Here are my additional comments regarding the Kentucky Pioneer Integrated Gassification Combined Cycle Demonstration Project Draft Environmental Impact Statement, January 24, 2002. These comments are in addition to the ones I verbally submitted at the public hearing in Lexington.

Kentucky Pioneer Integrated Gasification
Combined Cycle Demonstration Project
Draft Environmental Impact Statement
U.S. Department of Energy
National Energy Technology Laboratory

**Comments on the Kentucky Pioneer IGCC Draft
Environmental Impact Statement**

Figure 4.4 Temperature Profile of ARBRE Gasification System

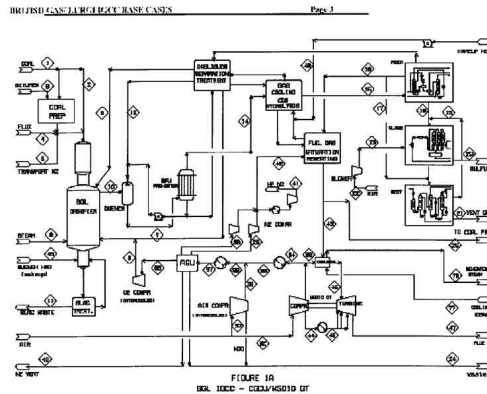
The environmental impact of an IGCC plant is a function of the thermal and chemical character of the facility. Section 3.1.1.2 should address the temperature profile of the pyrolytic products. Examples of the types of information missing are offered below:²⁴
